Planning Officer's Report – LDCA NOVEMBER 2021

| APPLICATION | 2021/80 – Proposed Covered Area, External and Internal Alterations and Demolition Works |
| APPLICANT | W A Thorpe & Sons Ltd |

Diagram 7: Site Plan

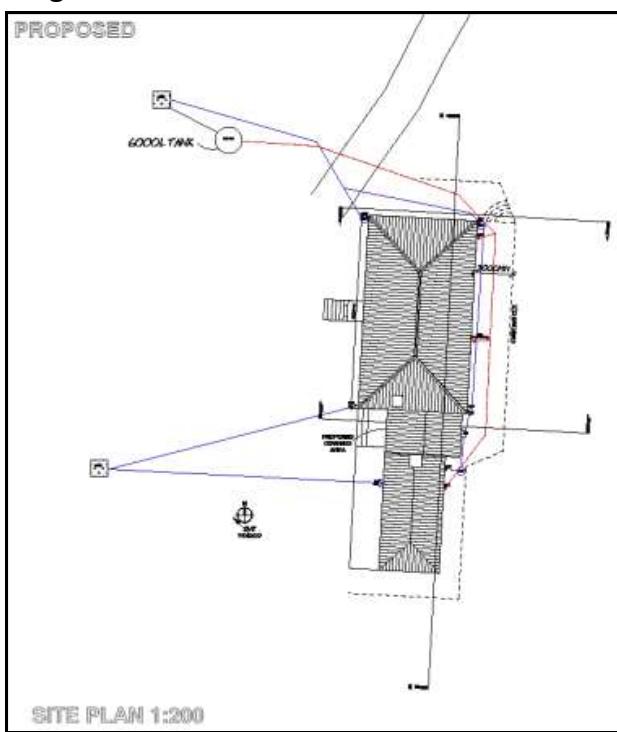
SITE: The entire site is 4.5 acres and enclosed with trees and shrubs. The proposed development doesn't change the footprint of the existing building thereby not acquiring additional land and thus doesn't have an impact on the site. Whilst there are changes to the appearance with new and adjusted windows on the main house and demolition of the link building creating a covered area, these are concealed within the forest setting and are in keeping with the style of the rest of the house, which complies with the Green Heartland Policies: GH.2 (b) & GH.3 (a).

Diagrams 8 & 9: Ground Floor & First Floor Plans (PROPOSED)

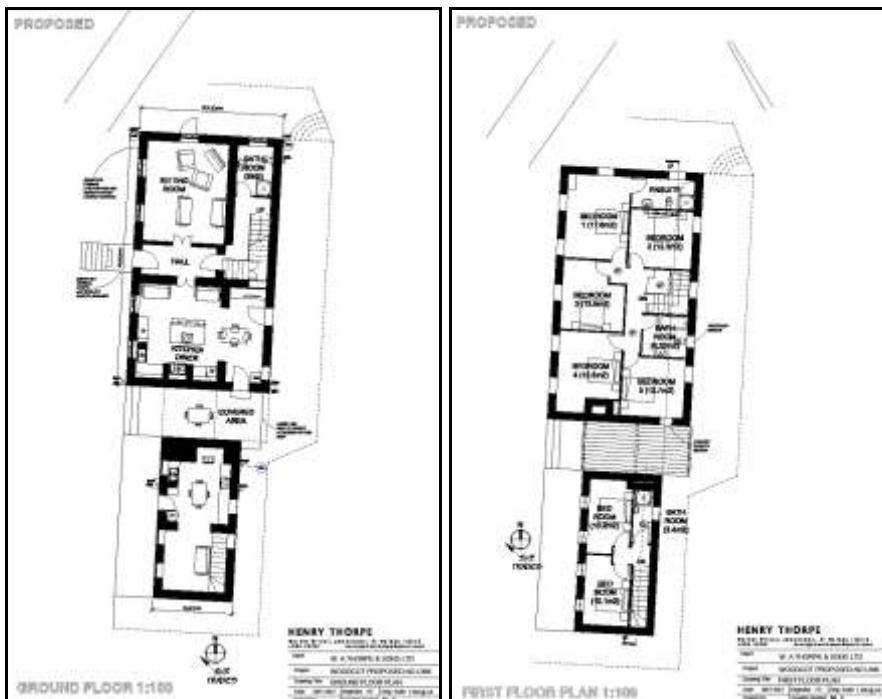
MAIN BUILDING: The internal alterations on the ground floor are generally minor in their impact and include the removal of a section of a non-load bearing wall to create a large kitchen and dining room.

Proposed alterations to the first floor includes a new layout to convert from two bedrooms into five bedrooms with the main bedroom with en-suite bathroom. The walls on the first floor that continue through from the ground floor are 100mm blockwork and mirrors the ground floor plan layout. It is proposed to remove these non-load bearing block walls on the first floor and construct all insulated stud partitions to create the five bedrooms. It is worth noting that the existing block walls on the first floor are not part of the original structure and ends at 50mm below the roof truss beams thus rendering the walls non-load bearing, the entire roof structure is supported on the external stone walls.

A new window is proposed at the rear of the building on the first floor to provide light and ventilation to the new bathroom. Whilst this additional window changes the appearance of the rear elevation it is sympathetic to the existing due to its size (1200x800mm) and design as a sliding sash similar to the existing.

Diagram 10: Rear Elevation & Section (PROPOSED)

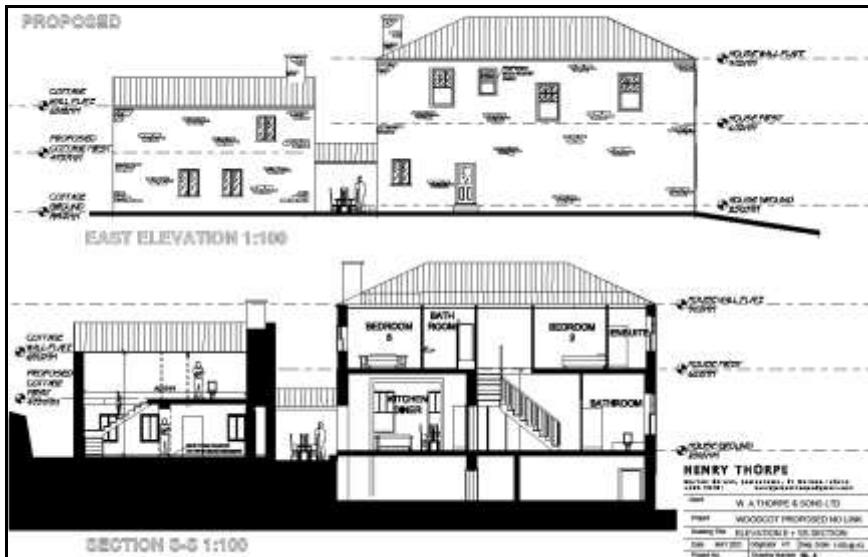
are flush with the eaves of the main house. The proposal is to demolish the link building and create an open area that is covered over with a roof structure at the first floor level. The covered area will be further set back from the main elevation of the house in line with the cottage, thus allowing the main building to stand as the core feature.

The LINK BUILDING is a newer structure and with its height and projected position was a detracting feature for the main building. Its removal is considered to be a huge improvement in the restoration of the main building. The covering over of the open space between the two buildings is not considered to be too prominent and will not be a detraction to the two buildings to stand independently of each other.
